Stepdown Fix Chart Note

ACF-CG RD 13-01-270

NBAA Access Committee

Washington, DC | October 30, 2014

Stepdown Fix Chart Note

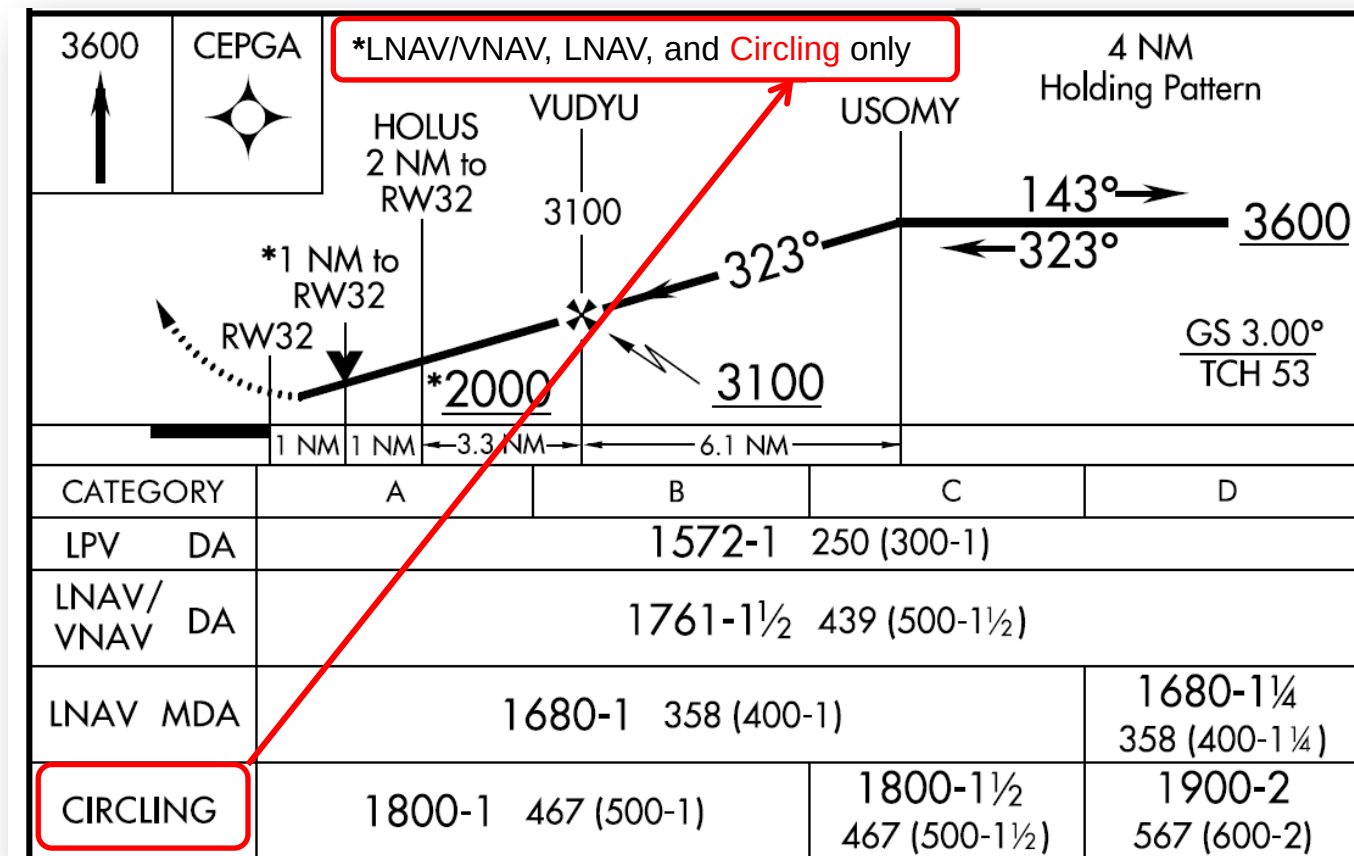
- Introduced by AIR 130 in April 2013
- Concerned the “LNAV only” note on the instrument approach profile view

“Many interpret this note as the Stepdown fix only applies to the LNAV line of minima. In actuality, the Stepdown fix applies to both the LNAV and LNAV/VNAV lines of minima due to certain avionics limitations; in particular because baro-VNAV can be used on an approach with LNAV/VNAV minima.”

- US IFPP decision to change Note from “LNAV only” to “LNAV/VNAV and LNAV only”
- Changes will be reflected:
 - AIM update scheduled for publication in January 2015
 - Next update of FAA Order 8260.19, Flight Procedures & Airspace
- Note will be applied either through amendment or P-NOTAM

LNAV/VNAV Minima

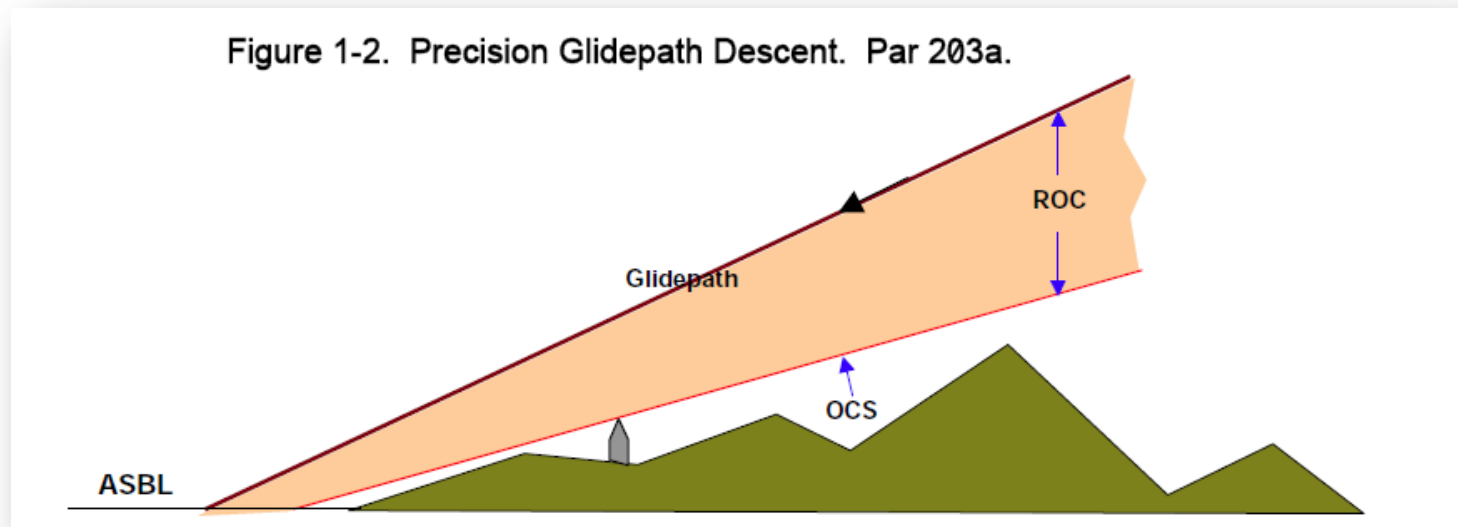
Must Also Include “Circling” In The Note

Example: Ames, IA RNAV (GPS) Rwy 1 approach

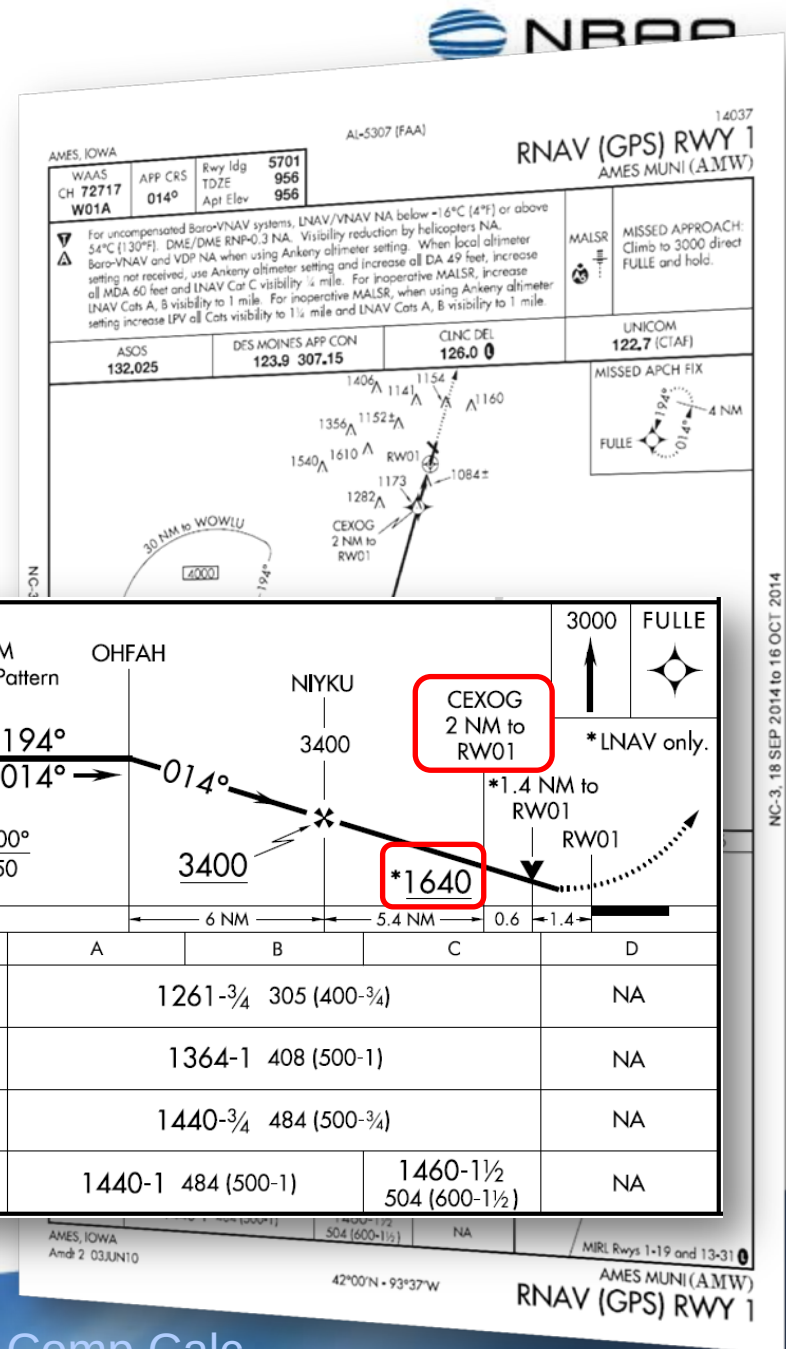
Cold temperature compensation raises stepdown fix altitudes

- Temp = - 10C
- CEXOG SDF height above airport = 648'
- Cold Temperature Compensation = 68'
- CEXOG temperature compensated crossing altitude = 1708'

What actions does the pilot take when approaching CEXOG on non-temperature compensated Baro-VNAV path?

VNAV Path Below Stepdown Fix Altitude

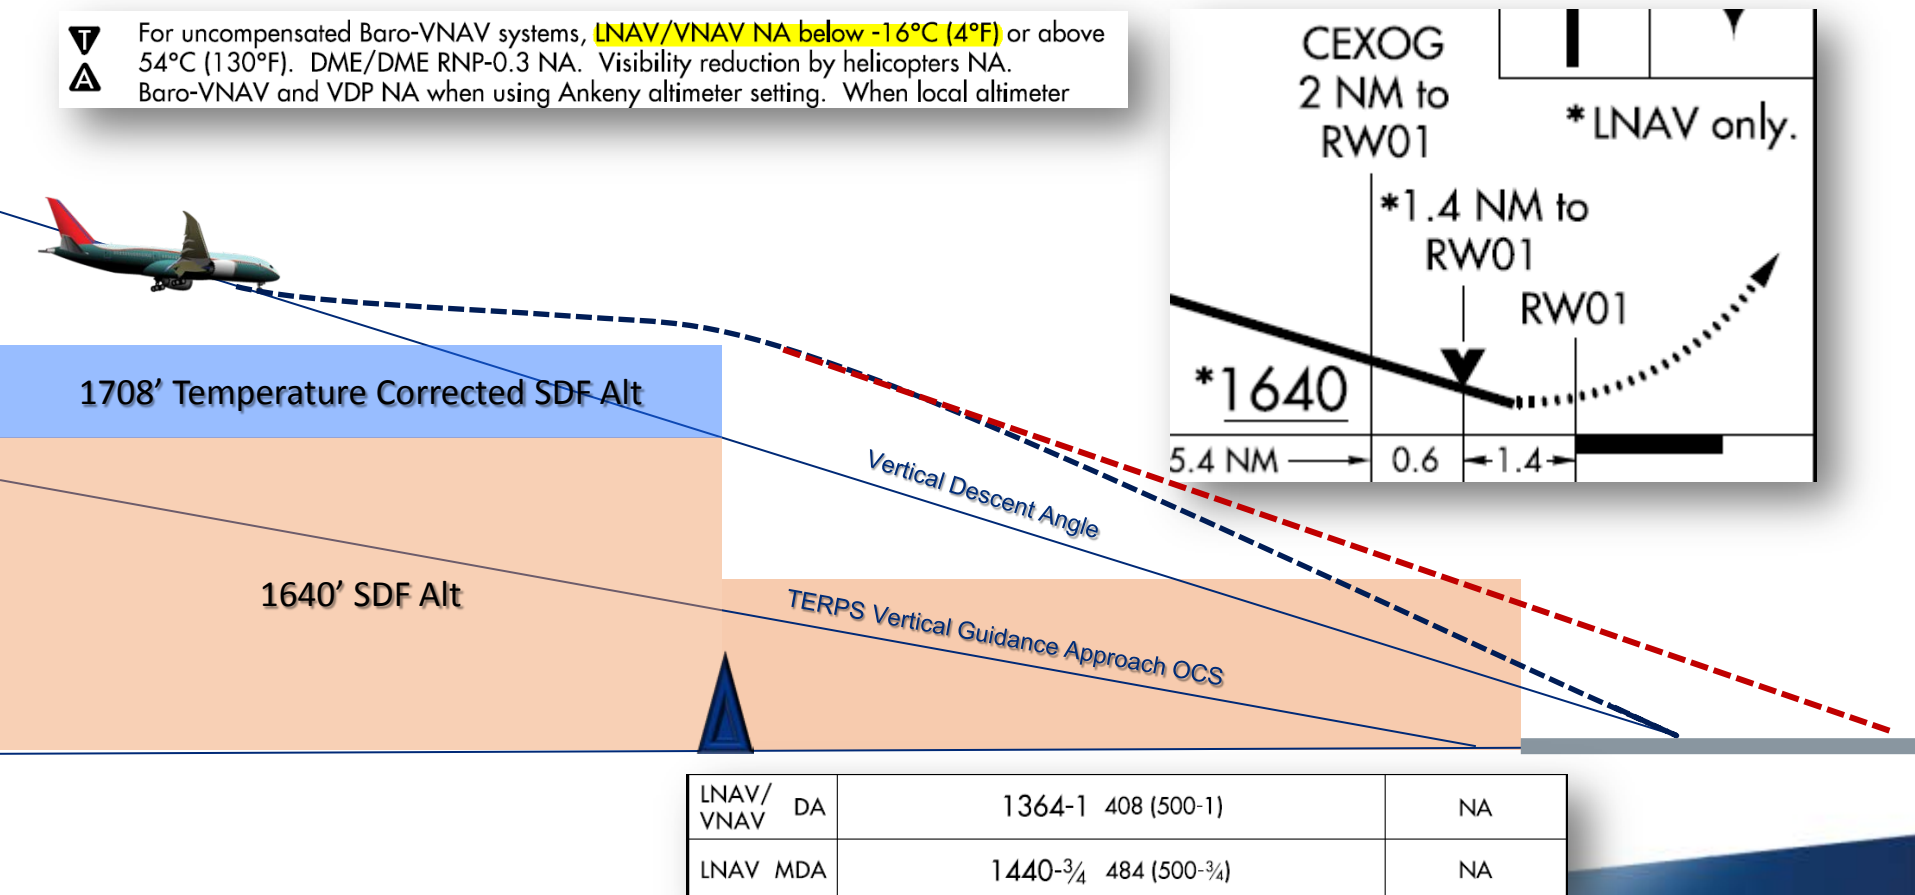
⚠ For uncompensated Baro-VNAV systems, **LNAV/VNAV NA below -16°C (4°F)** or above 54°C (130°F). DME/DME RNP-0.3 NA. Visibility reduction by helicopters NA. Baro-VNAV and VDP NA when using Ankeny altimeter setting. When local altimeter

Separate Charts

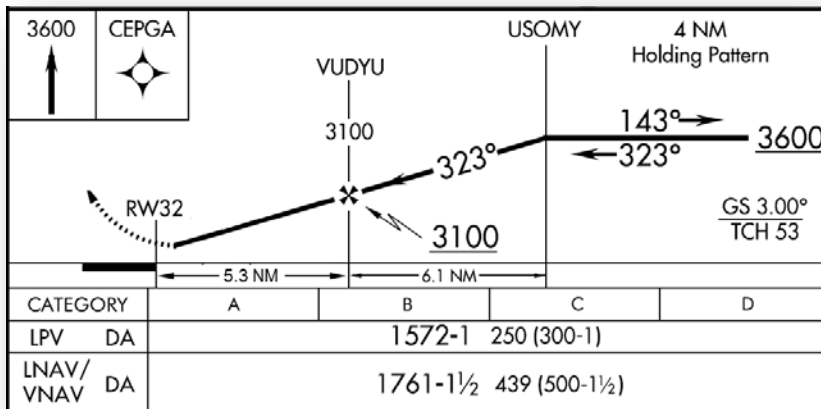
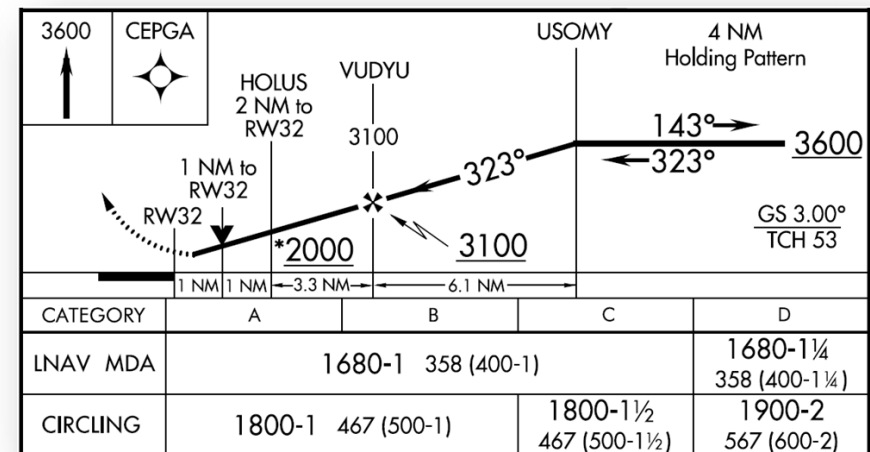
*Note 2: Do not establish altitude restrictions at fixes located between the PFAF and RWT on vertically guided approach procedures unless they are applicable to a non-vertically guided procedure **published on the same approach chart**.*

RNAV (GPS) **X** Rwy

RNAV (GPS) **Y** Rwy
